RFI

RFI #: 179
Date: 8/7/2012
Job: EB-02 Keller Springs Lofts
Phone: 877-777-5115

Subject: Hollow metal door at 7th level of stair tower #4

Drawing: 1/6.4, 1/3.7D
Cost Impact: None

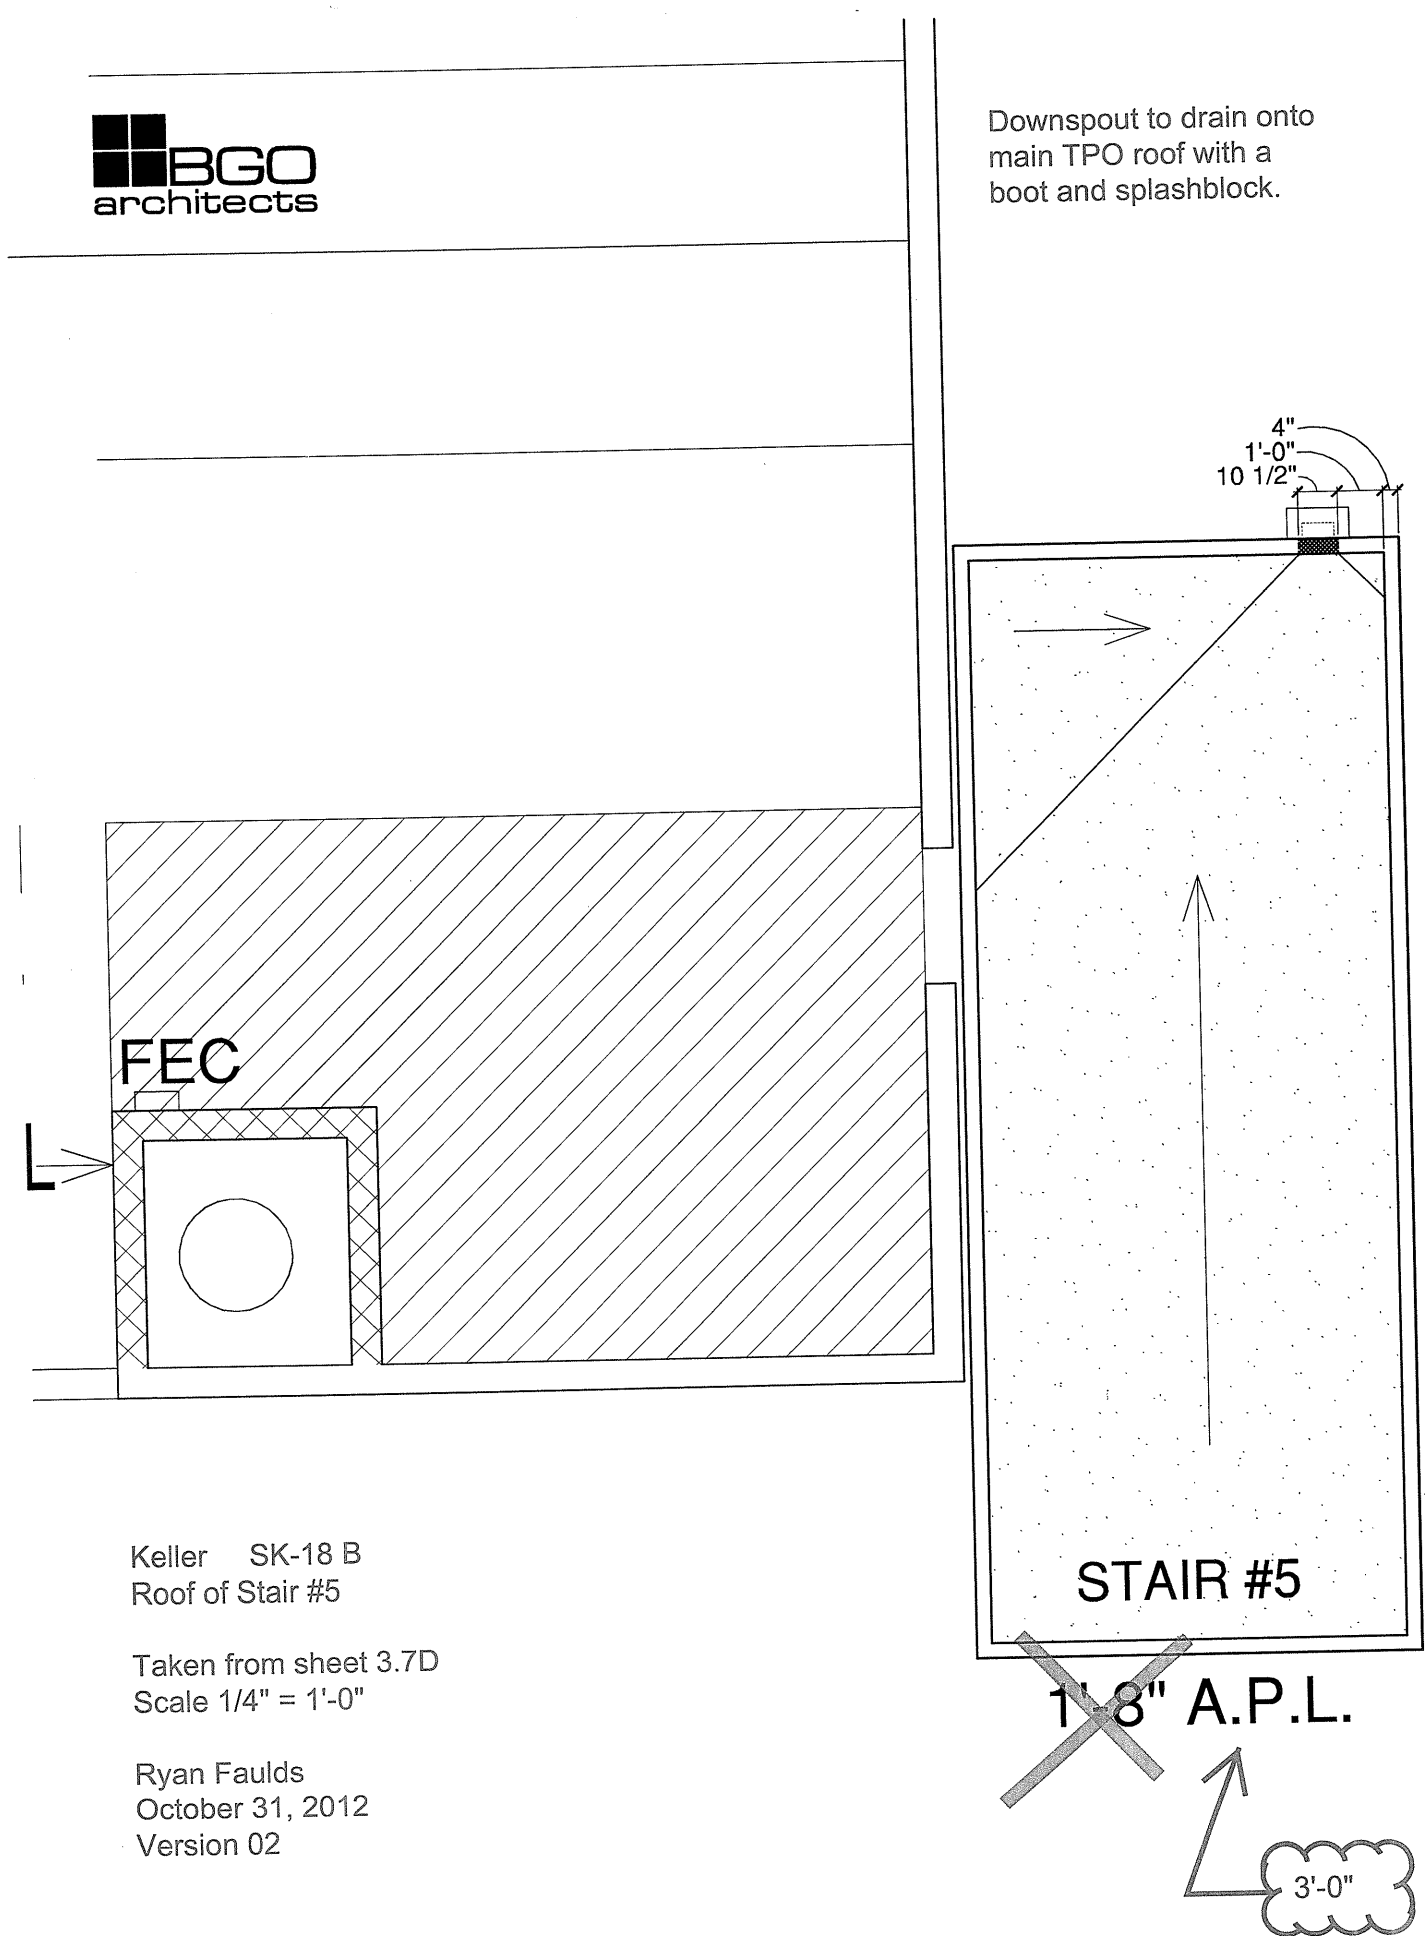
Request: The hollow metal door on the 7th level of stair tower #4 shows being mounted into the garage pre-cast wall, on the 7th level of the garage the pre-cast wall stops 42" above finish floor of the garage. Therefore, the door will have to be moved into the stair tower CMU wall. Since the door is a left hand swing I purpose we use the same door and swing it into the stair tower similar to stair tower #5 and solve this issue. Please advised and respond ASAP as we are up to the 4th level now with the CMU. **Date Required: 8/8/2012**

Response:
what you propose for the 7th floor door in stair tower #4 is acceptable.
